CONTRACT CHANGE ORDER NO. 122
SHEET 2 OF 9

MARK	DATE	DESCRIPTIONS	BY	CH'D	CCO#
1	07/31/09	LONGITUDINAL SHEAR PLATE	DT	GB	122

SAN FRANCISCO OAKLAND BAY BRIDGE
EAST SPAN SEISMIC SAFETY PROJECT
SELF-ANCHORED SUSPENSION BRIDGE
(SUPERSTRUCTURE & TOWER)

TYPICAL GIRDER DETAILS NO. 5

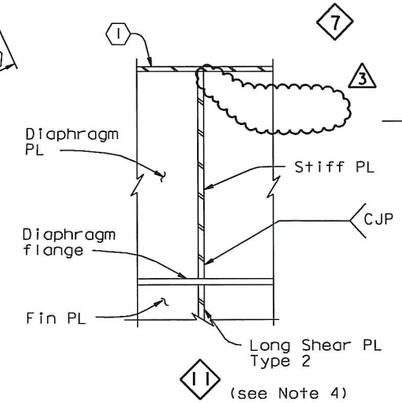
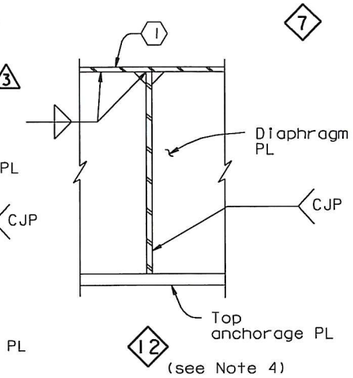
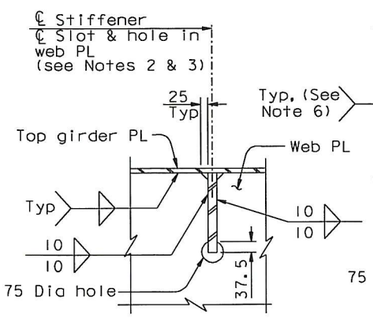
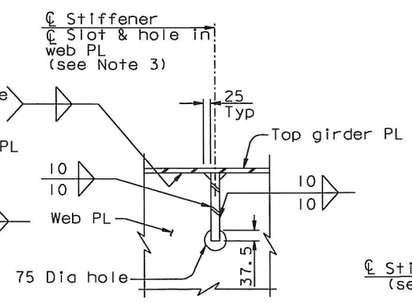
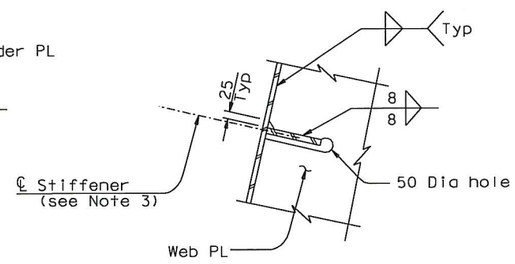
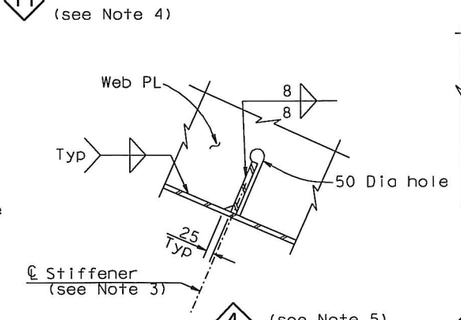
MARK	DATE	DESCRIPTIONS	BY	CH'D	CCO#
3	07/31/09	LONGITUDINAL SHEAR PLATE	GB	DT	122
2	02/20/09	SUSPENDER BRACKETS	GB	DT	104
1	01/26/06	ADD STIFFENER TYPES 13 THRU 18	GB	NV	22

TYPICAL GIRDER DETAILS NO. 7

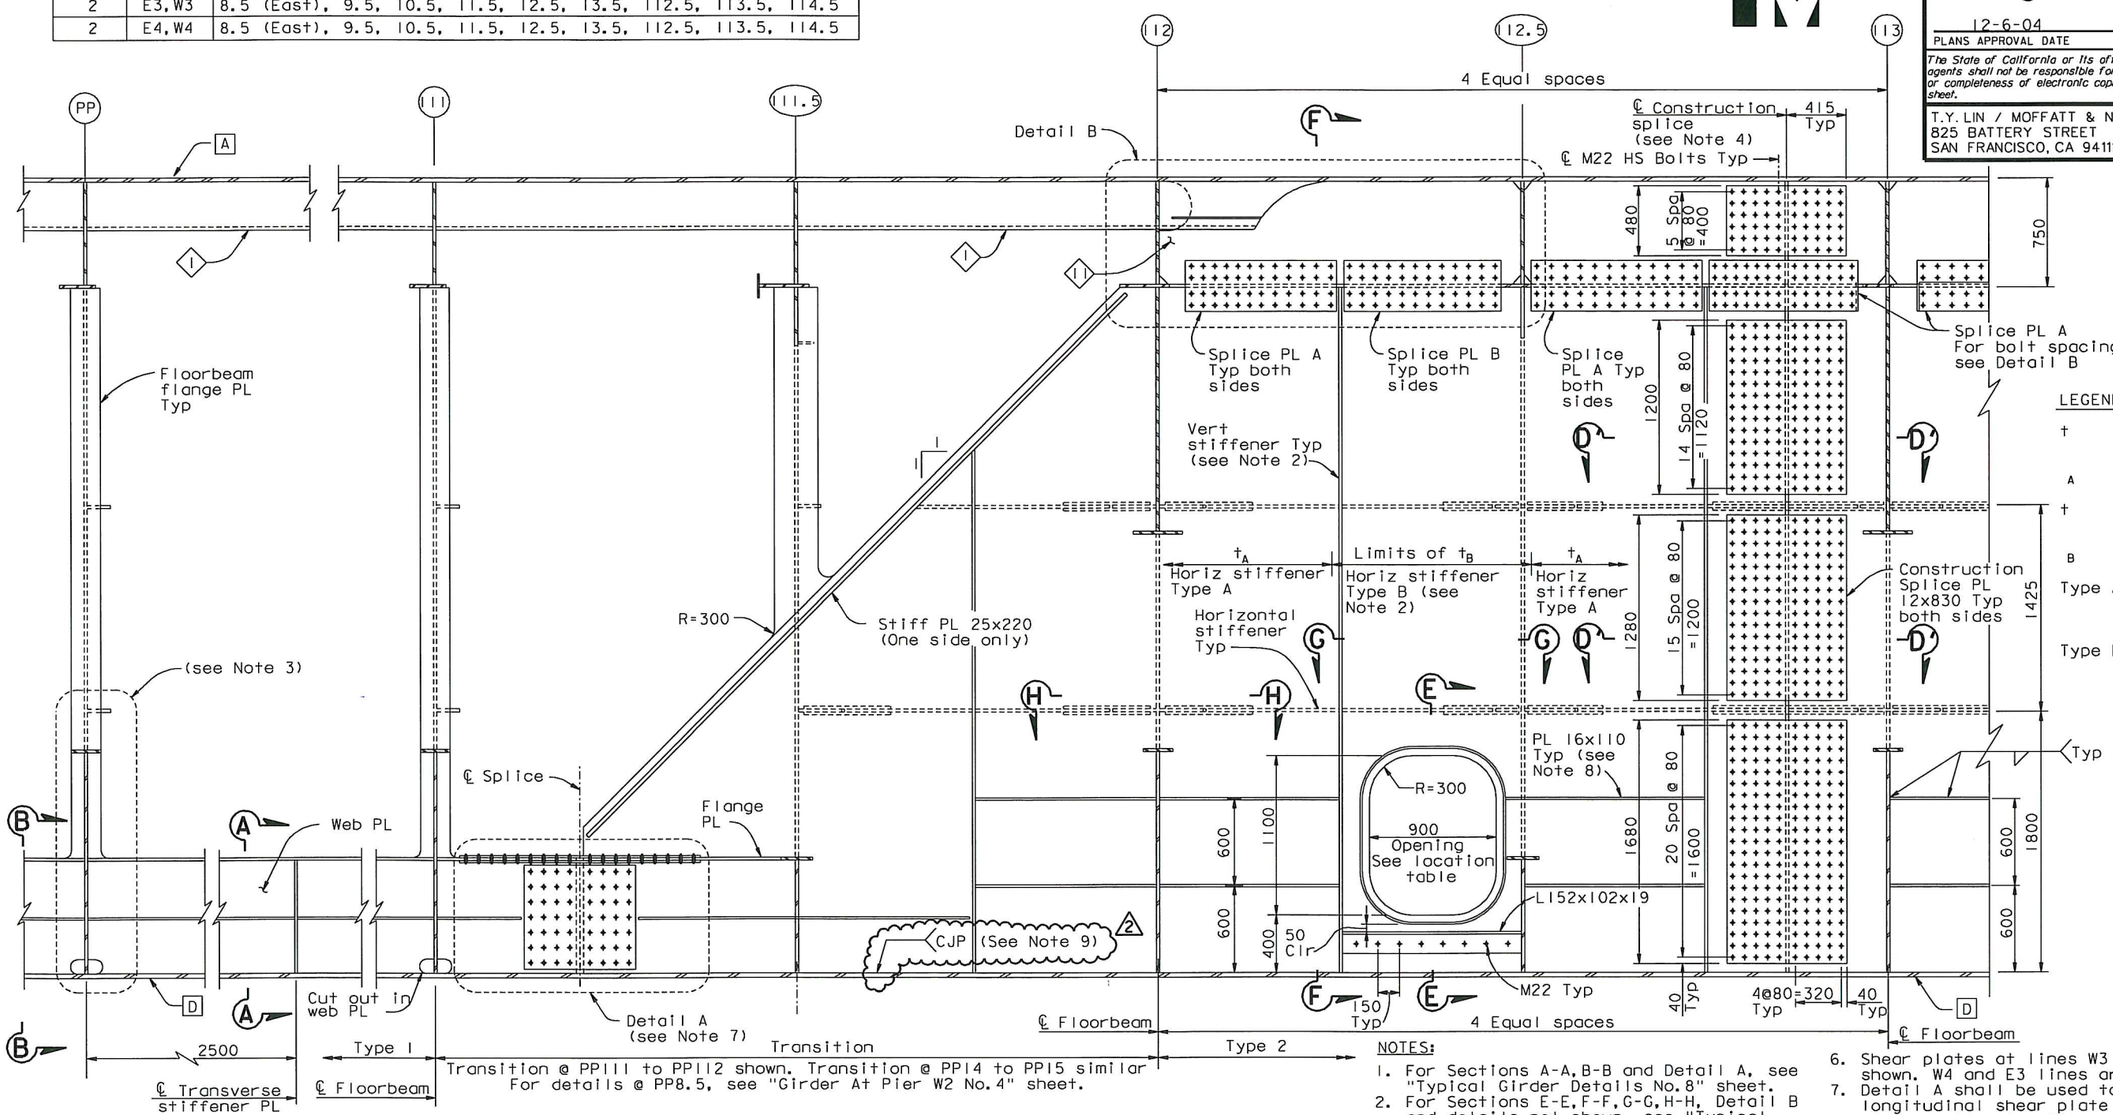
MARK	DATE	DESCRIPTIONS	BY	CH'D	CCO#
2	07/31/09	LONGITUDINAL SHEAR PLATE	DT	GB	122
1	07/30/07	HINGE A REACTION-SHEAR PLATES	DT	GB	50

2 9. The Longitudinal Shear Plate to Girder Face "D" weld shall be a CJP from the CL Splice near PP111 to PP128.7.

TYPICAL GIRDER DETAILS NO. 9

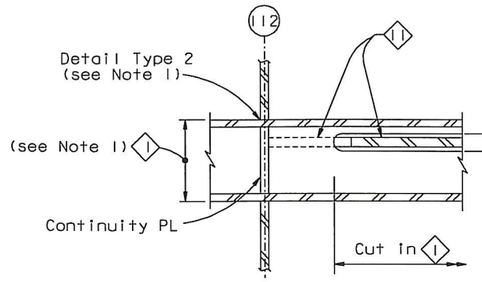
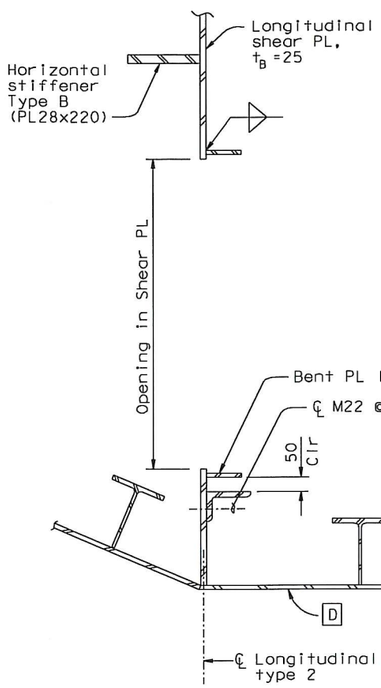
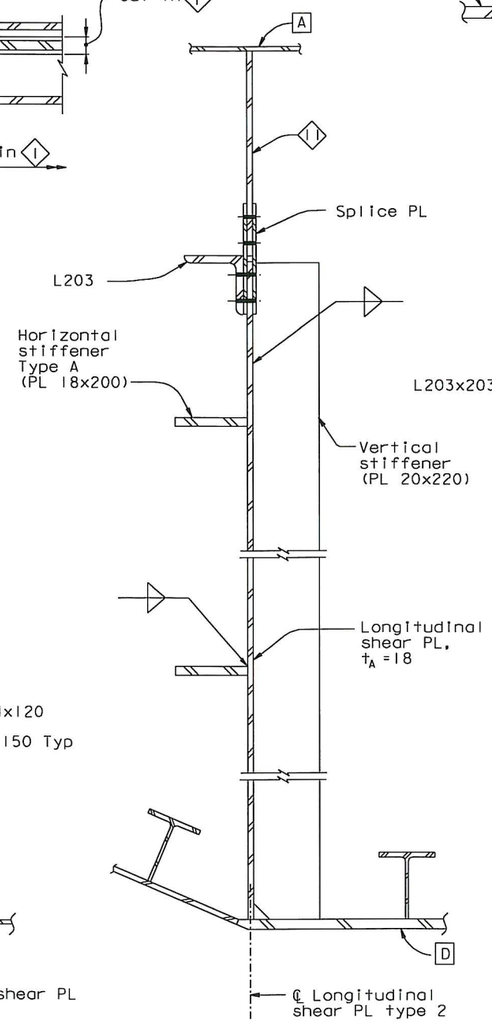
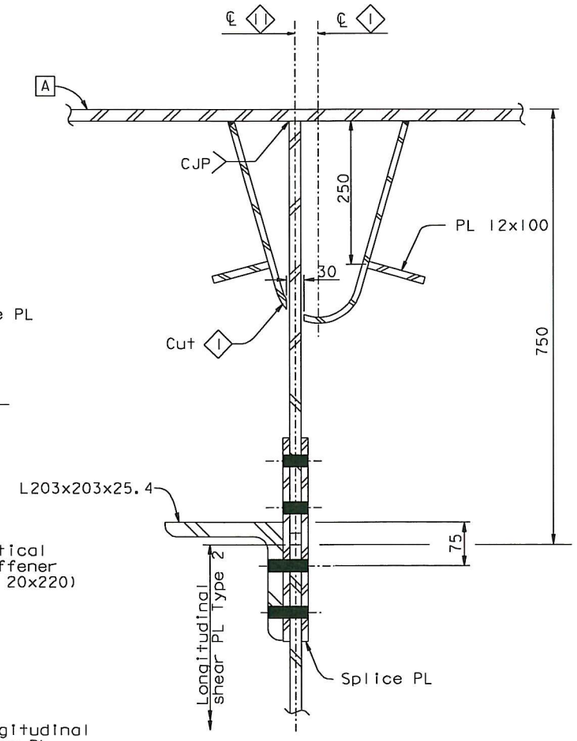
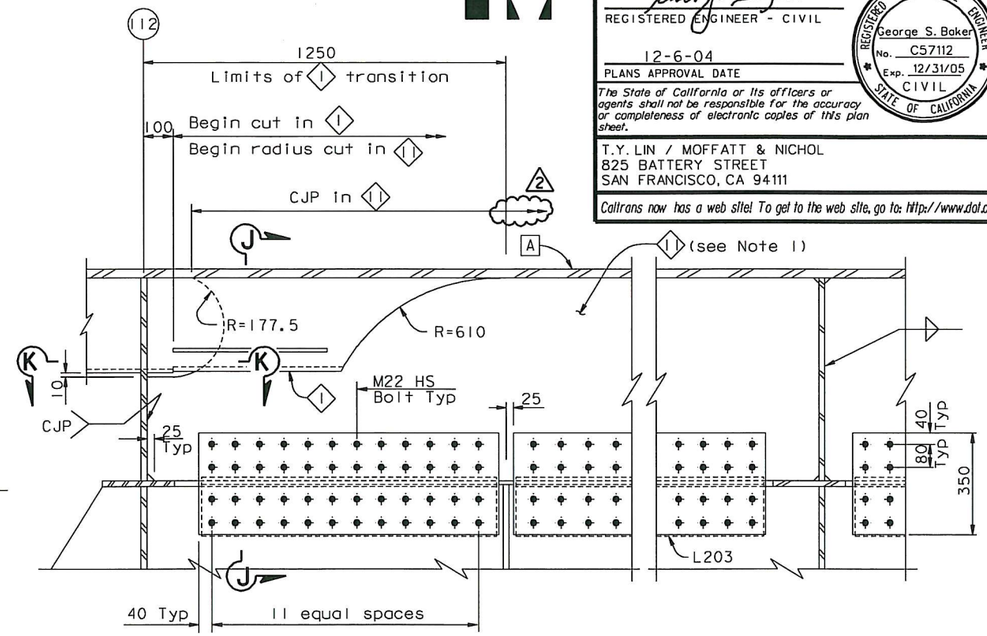
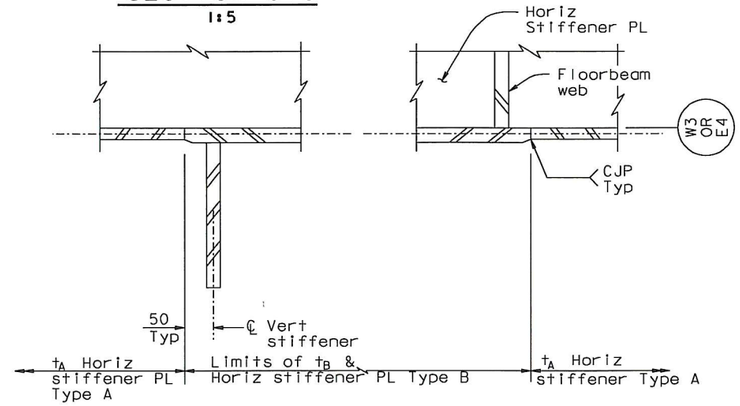
MARK	DATE	DESCRIPTIONS	BY	CH'D	CCO#
2	07/31/09	LONGITUDINAL SHEAR PLATE	DT	GB	122
1	07/30/07	HINGE A REACTION-SHEAR PLATES	DT	GB	50

GIRDER AT PIER E2 NO.2

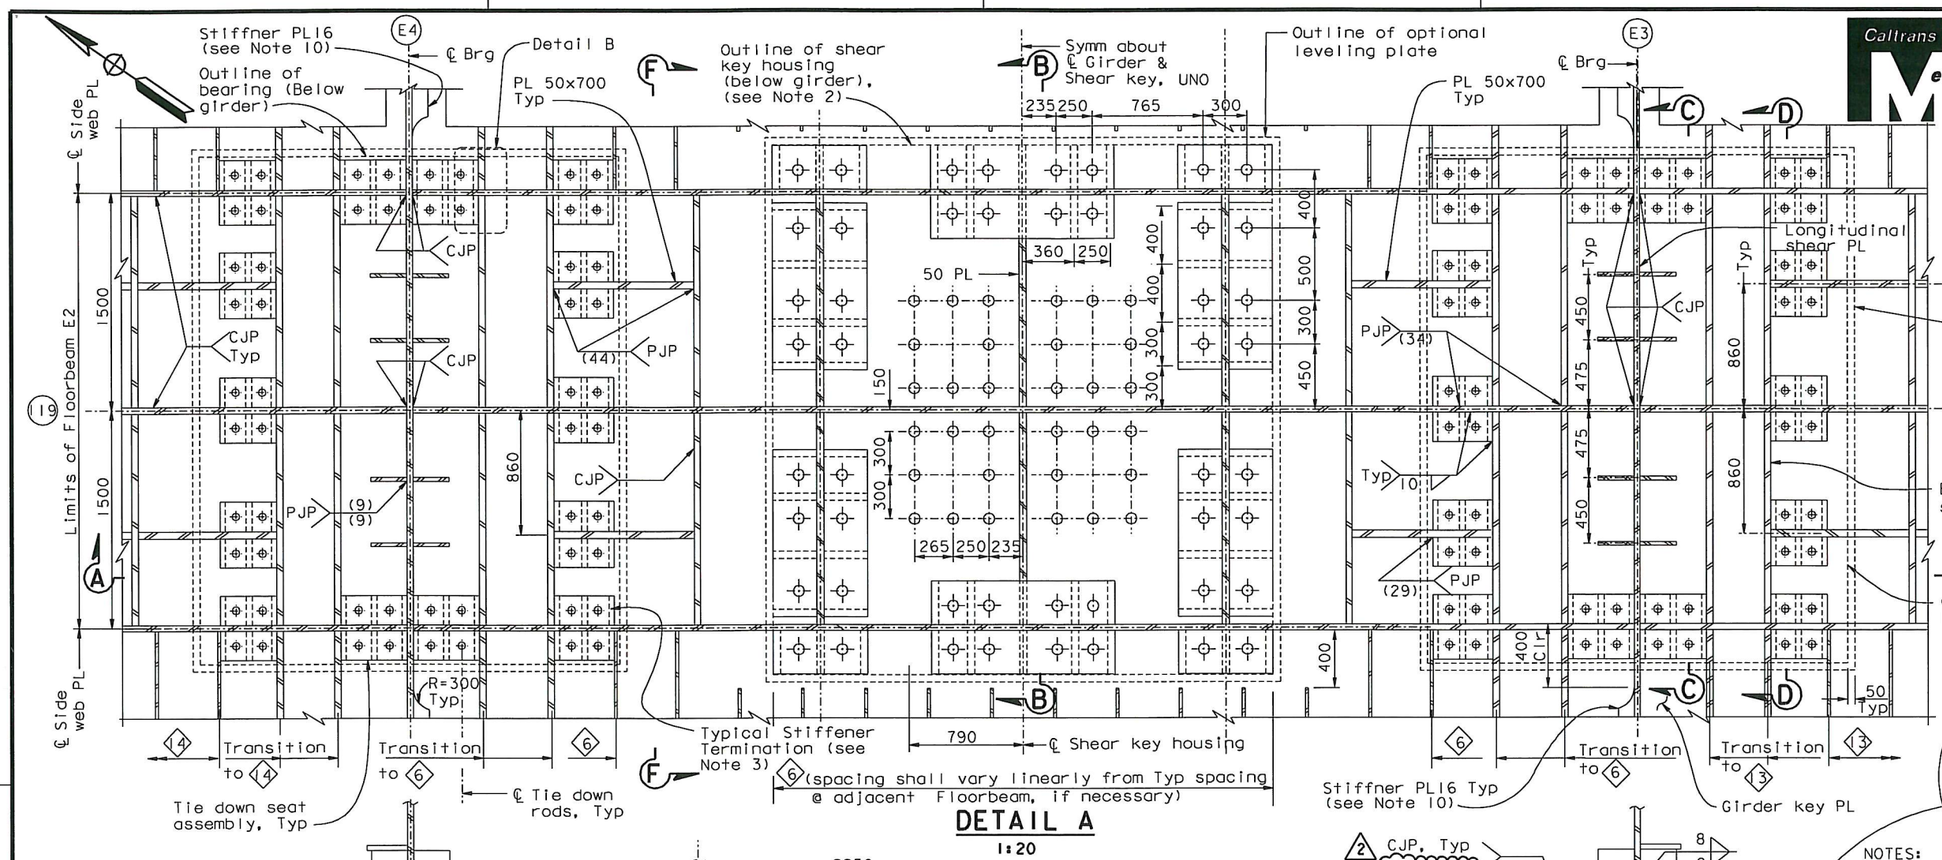
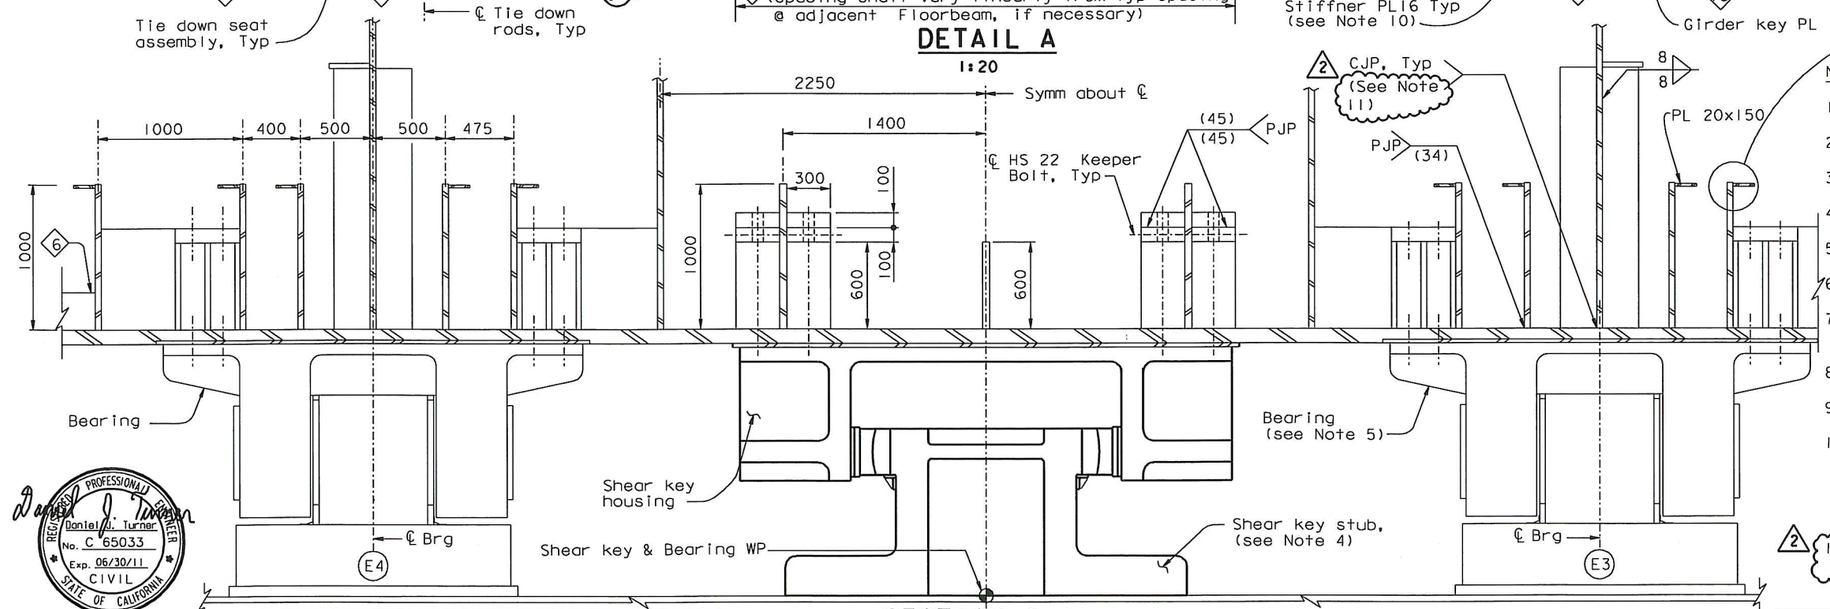
MARK	DATE	DESCRIPTIONS	BY	CH'D	CCO#
2	07/31/09	LONGITUDINAL SHEAR PLATE	DT	GB	122
1	07/30/07	HINGE A REACTION-SHEAR PLATES	DT	GB	50

11. For extent of CJP weld, see Note 12 on "Typical Girder Details No.7" sheet.

GIRDER AT EAST TRANSITION NO. 15

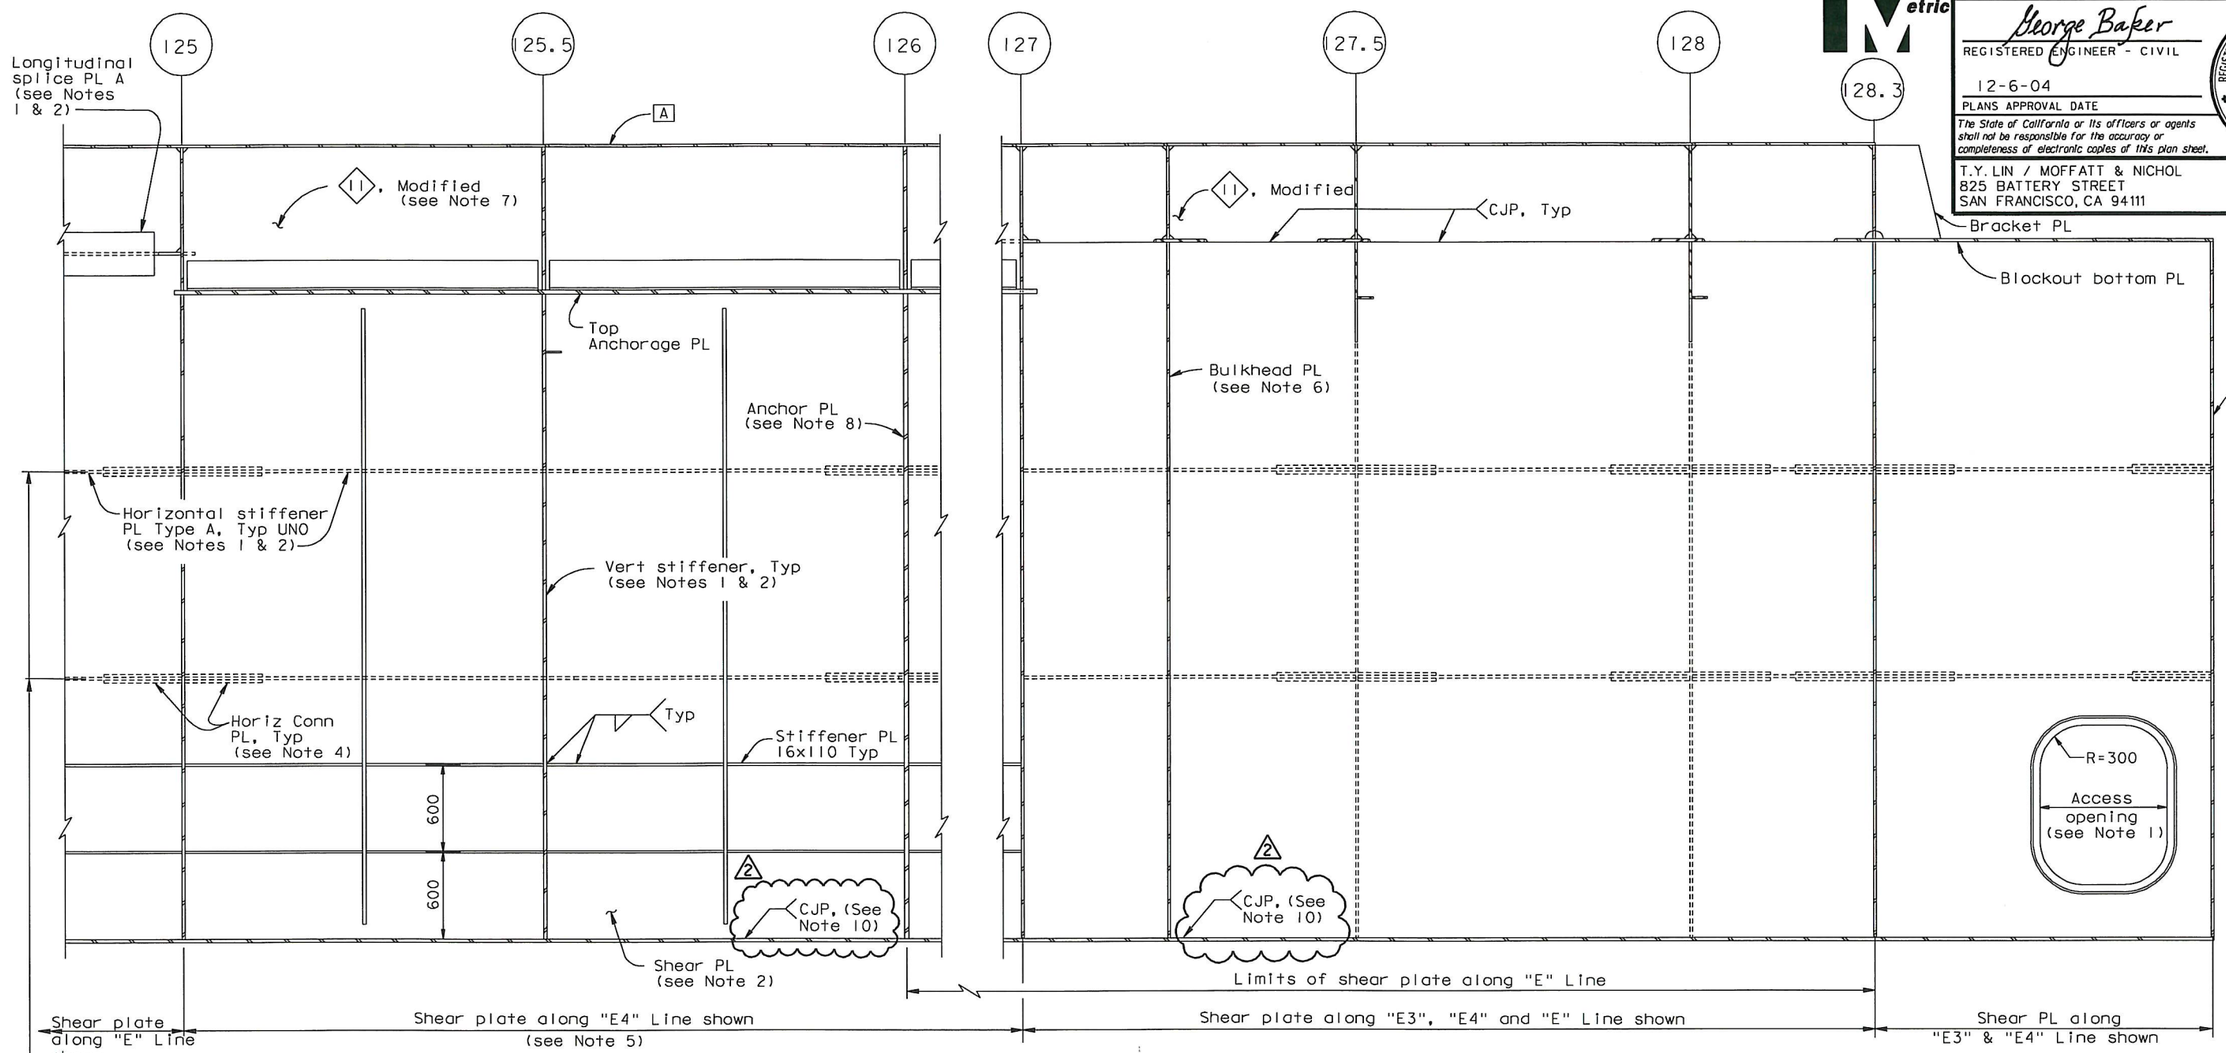
MARK	DATE	DESCRIPTIONS	BY	CH'D	CCO#
2	07/31/09	LONGITUDINAL SHEAR PLATE	DT	GB	122
1	07/30/07	HINGE A REACTION-SHEAR PLATES	DT	GB	50

10. The Longitudinal Shear Plate to Girder Face "D" weld shall be a CJP from the CL Splice near PP111 to PP128.7.
